DOCUMENT 00 9010
ADDENDUM NUMBER 01

DATE: **October 6,2022**
PROJECT: SE Branch Library Parking Lot Replacement
PROJECT NUMBER: PJ000106
OWNER: City of Arlington
ARCHITECT: Simon Engineering & Consulting, Inc.
 15443 Knox Trail Drive, Suite 140
 Dallas, TX
 Ph: (214) 884-2056
TO: Prospective Bidders

**CITY OF ARLINGTON
SE BRANCH LIBRARY PARKING LOT REPLACEMENT
QUANTITY SUMMARY**

CITY OF ARLINGTON, TEXAS
 ARLINGTON PUBLIC LIBRARY SOUTHEAST BRANCH
EROSION CONTROL PLAN
 900 SE GREEN OAKS BLVD, ARLINGTON, TX 76018

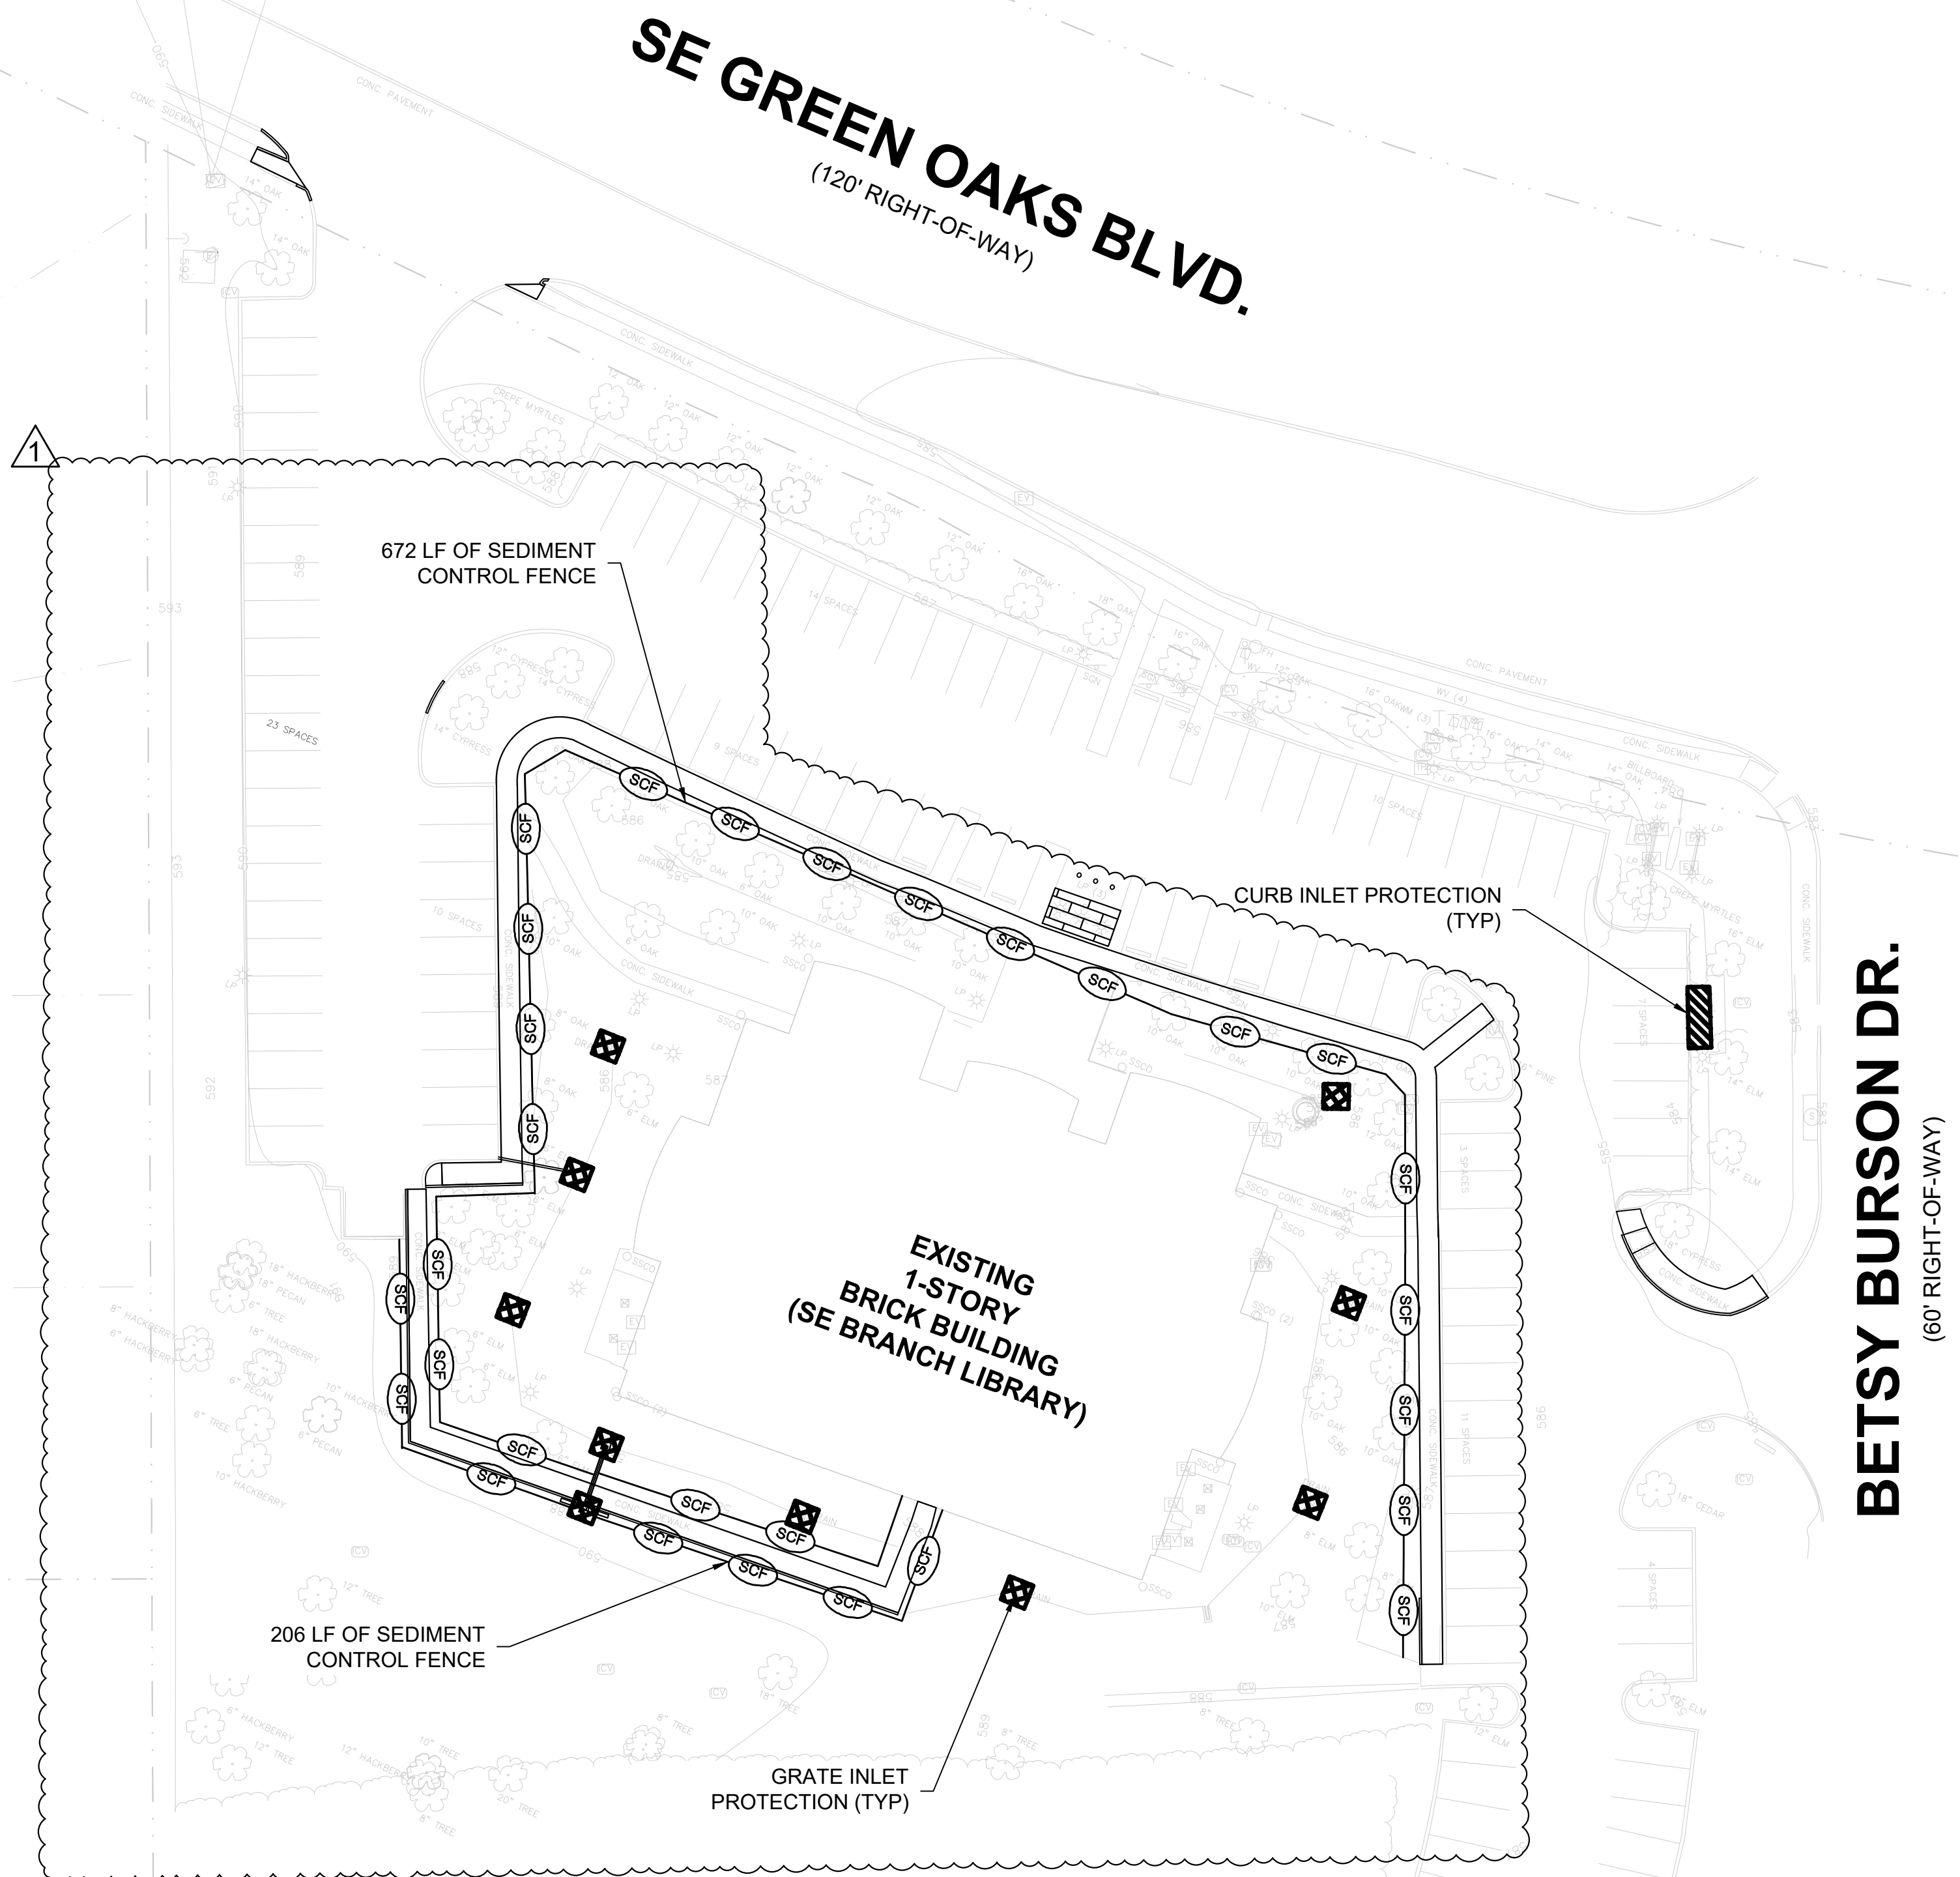
| No. | Date | Revisions |
|-----|------------|-----------------------------|
| 1 | 10/05/2022 | ADDITIONAL INLET PROTECTION |
